Failure Analysis Report

0000628: [Eagle] the rebooting infinite loop during power on

Figure 1. Simulate thumb to touch component

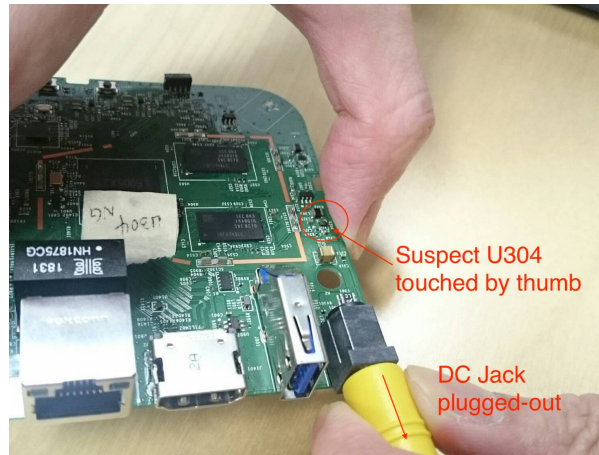
1. Check DDR power rail P1V2, the result is no power output.
2. Check the PP_PW R_IN=5.1V, the result is ok.
3. Check the resistance conductivity on pin 4 which is output pin, compared with good PCBA. The result is 0.6V. Good PCBA is 1.1V.
4. Power on again and check console log, the fail symptom seems relative to DDR while P1V2 is no power output.
5. Change a new one power IC of U304 and the PCBA is good to boot up.
6. Suspect that when plugged-out the DC Jack power cable, thumb is very close to U304. So far there is no housing to cover the PCBA and the fingers to touch components risk are very high.
7. Please see figure 1 simulated as thumb to touch the U304 while plugged-out DC Jack cable.

Suspect the fingers and thumb to touch component, that ESD or short components while PCBA is power on and has very high risk without housing to cover PCBA. Even U305 has risk to be touched. Please see figure 1.
